AGENDA

PLANNING & ZONING COMMISSION REGULAR MEETING TUESDAY, FEBRUARY 4, 2025 - 3:00 PM MCALLEN CITY HALL, 1300 HOUSTON AVENUE CITY COMMISSION CHAMBERS, 3RD FLOOR

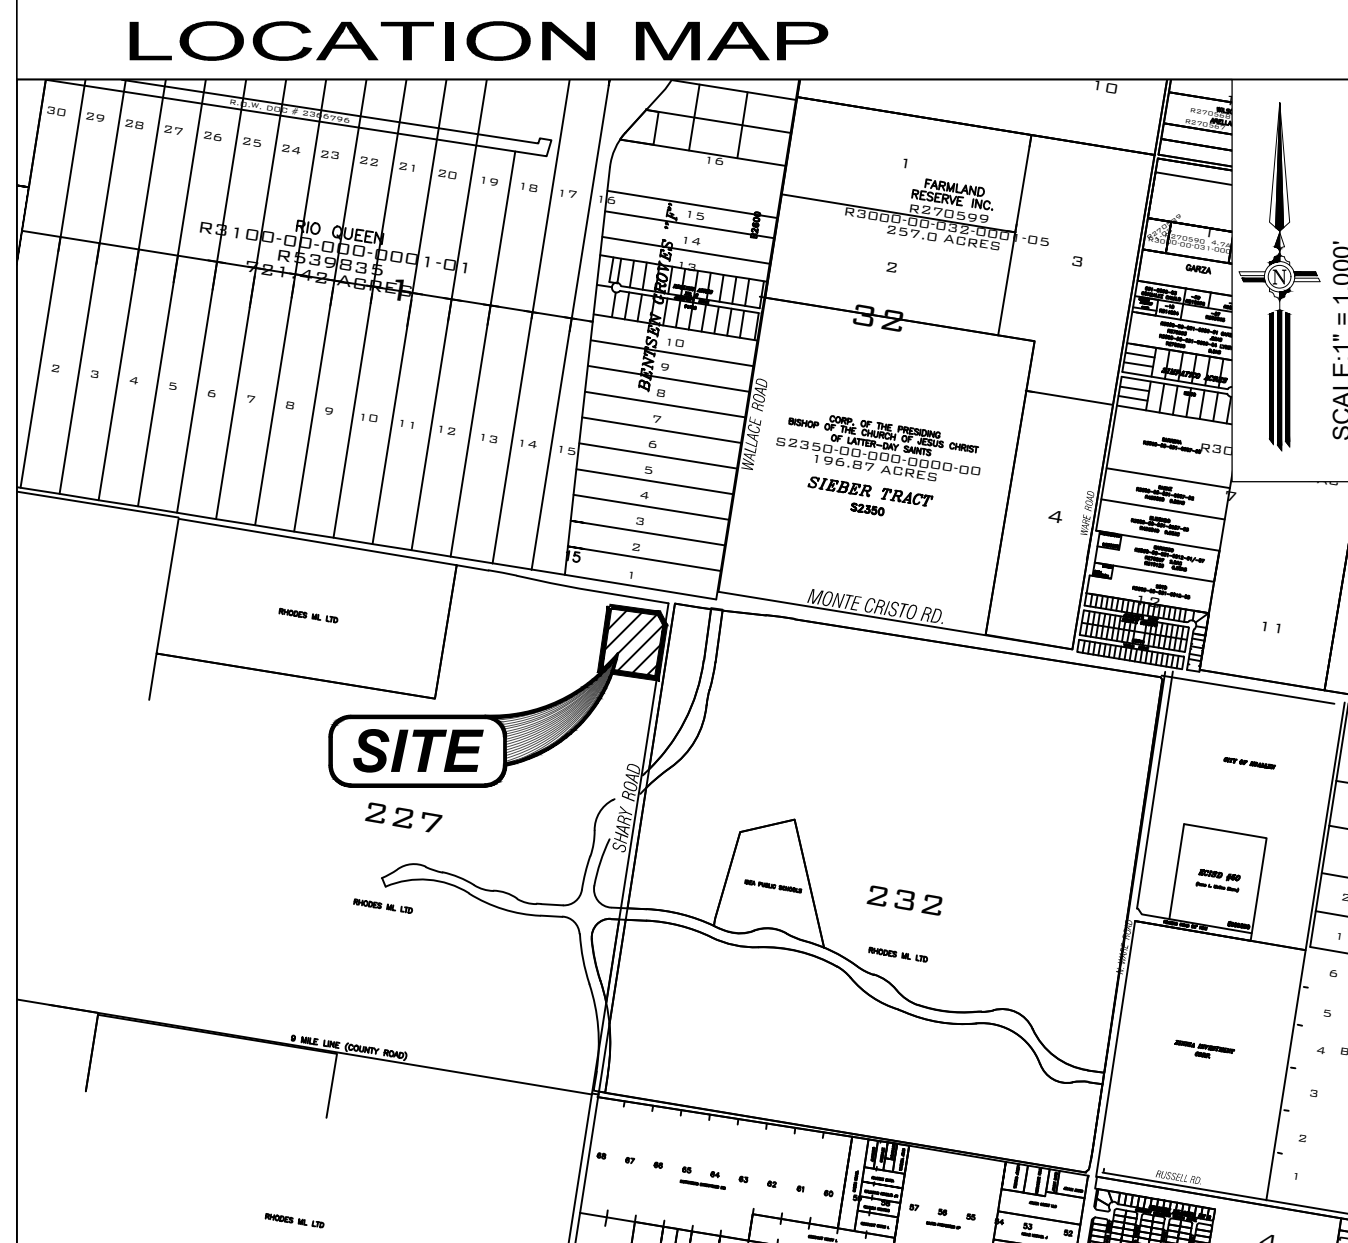
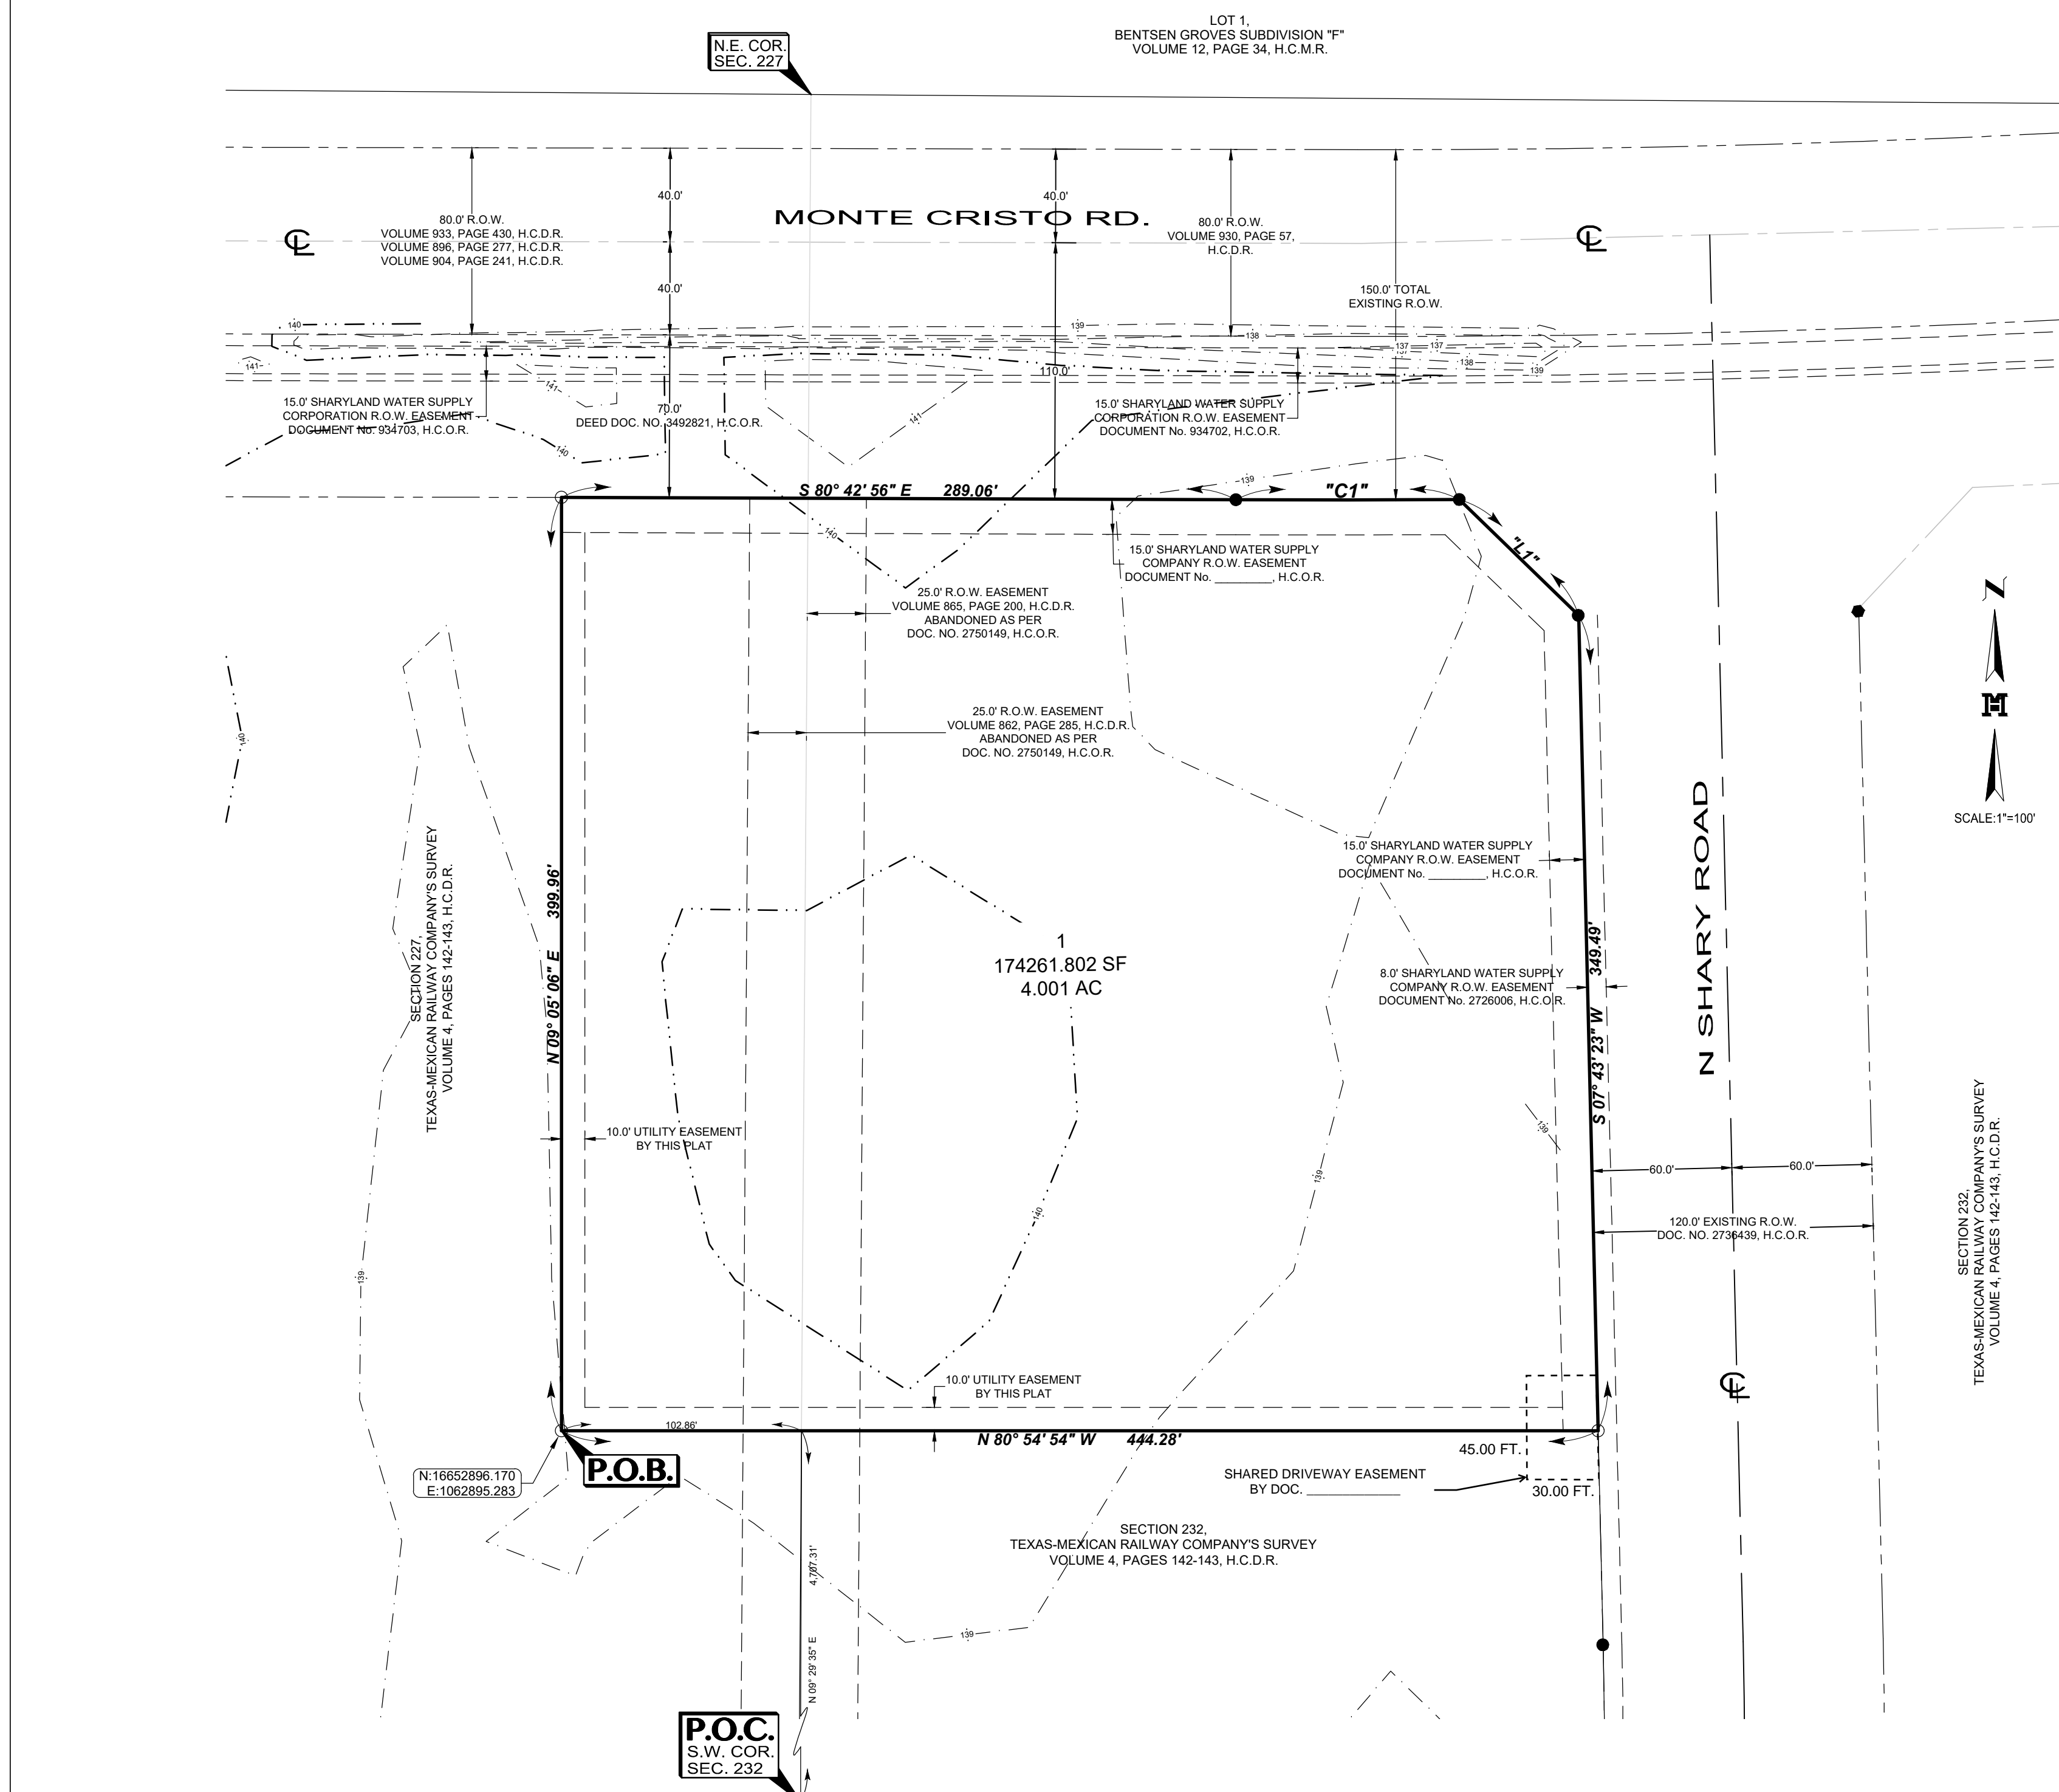
SUBDIVISION NAME: TEX-BEST AT TRES LAGOS	
REQUIREMENTS	
STREETS AND RIGHT-OF-WAYS	
<p>Monte Cristo Rd.: R.O.W. required from centerline for 150 ft. of total R.O.W. Paving: 65' B-B Curb & gutter: Both Sides Revisions needed: -Provide a COPY of all the R.O.W. documents along monte cristo road for staff review prior to final/recording. **Disclaimer: Abandonment of easements cannot be done by plat, must be done by a separate instrument/document. -All R.O.W. requirements must be addressed prior to final/recording. **Subdivision Ordinance: Section 134-105 **Monies must be escrowed if improvements are not built prior to recording. **COM Thoroughfare Plan</p>	Required
<p>N. Shary Road: 60 ft. R.O.W. dedication required from centerline for 120 ft. of total ROW. Paving: by State Curb & gutter: by State Revisions needed: -Need to provide a copy of the R.O.W. documents for staff review prior to final. -Disclaimer: Abandonment of easements cannot be done by plat, must be done by a separate instrument. -All R.O.W. requirements must be addressed prior to final. **Subdivision Ordinance: Section 134-105 **Monies must be escrowed if improvements are not built prior to recording. **COM Thoroughfare Plan</p>	Required

ALLEYS	
<p>R.O.W.: 20 ft. Paving: 16 ft. - ALLEY required for commercial properties. - If a private service drive easement is proposed, minimum 24 ft. paved width is required and cannot be dead-end. Maintenance of such service drive is by the property owner and not the City of McAllen. Revisions needed: Make sure to add to plat note #14 the final wording, "...maintained by the property owner, not the City of McAllen." **Subdivision Ordinance: Section 134-106</p>	Required
SETBACKS	
<p>* Front: (Monte Cristo Road & N. Shary Road) In accordance with the Zoning Ordinance or greater for approved site plan or easements or inline with existing structures, whichever is greater applies. **Zoning Ordinance: Section 138-356</p>	Applied
<p>* Rear: In accordance with the Zoning Ordinance or greater for approved site plan or easements, whichever is greater applies. **Zoning Ordinance: Section 138-356</p>	Applied

<p>- Common Areas, any private service drive easements, gate areas, etc. must be maintained by the lot owners and not the City of McAllen. Revisions Needed: Please revise plat note #14 as shown above, prior to final/recording.</p> <p>* Common Areas for commercial developments provide for common parking, access, setbacks, landscaping, etc.</p> <p>* Developer/Homeowner's Association/Owner, their successors and assignees, and not the City of McAllen shall be responsible for compliance of installation and maintenance and other requirements per Section 134-168 of the Subdivision Ordinance, including but not limited to common areas and its private streets. **Section 134-168 applies if private subdivision is proposed. **Landscaping Ordinance: Section 110-72 **Subdivision Ordinance: Section 134-168</p> <p>* Homeowner's Association Covenants must be recorded and submitted with document number on the plat, prior to recording. **Section 134-168 applies if private subdivision is proposed. **Landscaping Ordinance: Section 110-72 **Subdivision Ordinance: Section 134-168</p>	Required

COMMENTS	
<p>Comments:</p> <ul style="list-style-type: none"> -Need to provide copies of documents for the abandoned R.O.W. easement that goes from North-South located on the plat for staff review prior to final/recording. -Please provide documents giving Mr. Brad Frisby authority to sign on behalf of ML Rhodes, LTD and revise application as needed prior to final/recording. *Disclaimer: Similar documents have been provided for other Rhodes projects, send it to us so we can add it on the case file for this project. -Need to Provide the Documents to verify who is authorized to sign on behalf of the LLC, LTD. etc. *Disclaimer: Similar documents have been provided for other Rhodes projects, send it to us so we can add it on the case file for this project. -Owner's Authorization mentions an LLC, application mentions and LTD, please clarify and revise application as needed. -Please verify that application matches what is stated on the plat as plat labels the property as a 4.001 A.C. while the application labels it as a 8.323 acre tract of land. *Application would need to be revised to reflect proper plat acreage. -Please provide a current Signed and Sealed Metes and Bounds Description and Survey for Staff review. -Please add page numbers at the bottom of the plats, ""e.g. Page 1, Page 2"" -Location map is missing the scale. -Please add the dimension for 341.42 ft. on the Southern portion of the boundary line as the M +B makes mention of this dimension but is not shown. -At the Planning and Zoning Commission meeting of June 18, 2024, the board voted to approve the subdivision in preliminary form subject to conditions noted, drainage and utility approvals. *Disclaimer: There is a small misspelling at the surveyor's seal, currently states ""Registrd"" instead of Registered. *Must comply with City's Access Management Policy. 	Required
